# FRDM-KE02Z

# FRDM-KE02Z40M

# FRDM-KE04Z

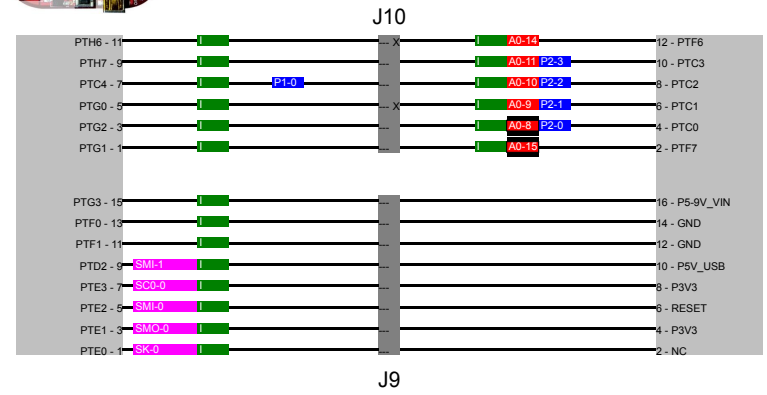
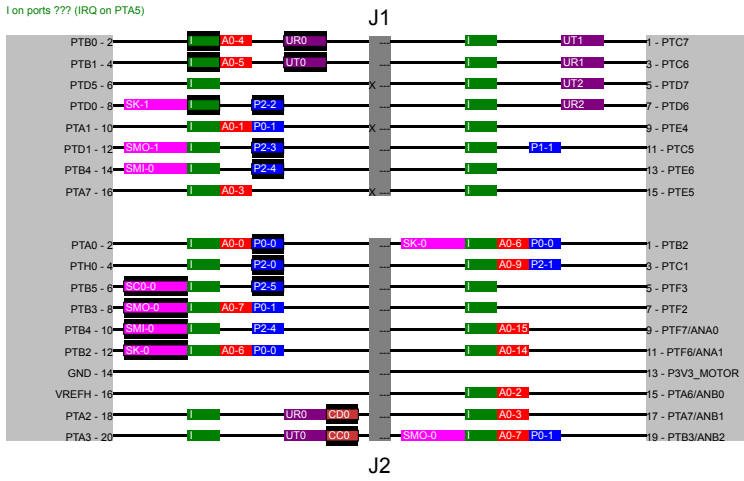
I on ports ??? (IRQ on PTAs)

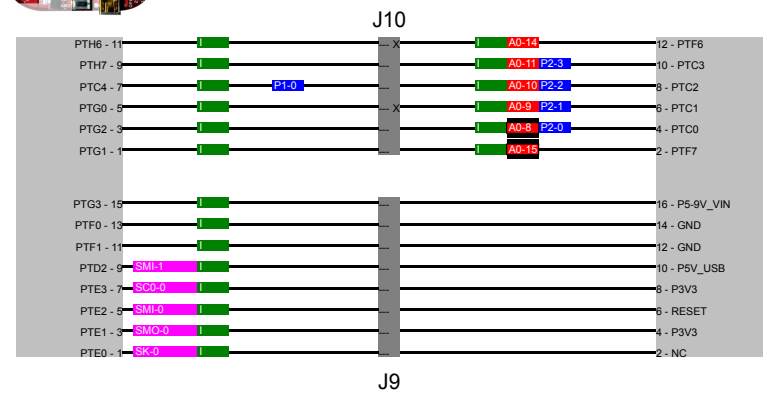
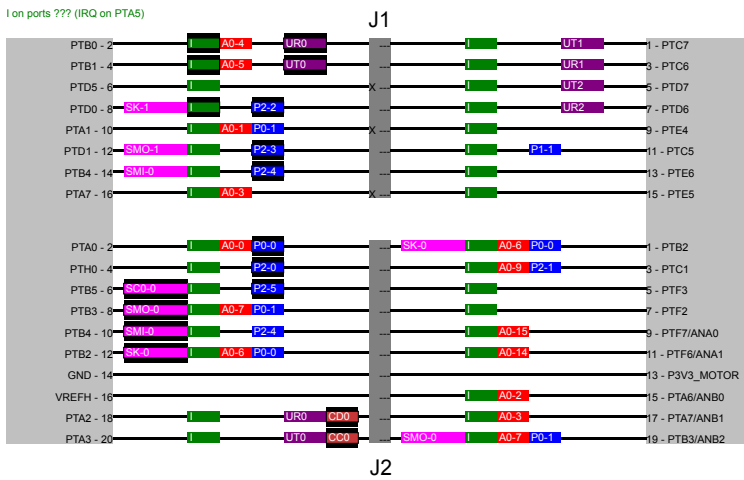
I on ports ??? (IRQ on PTAs)
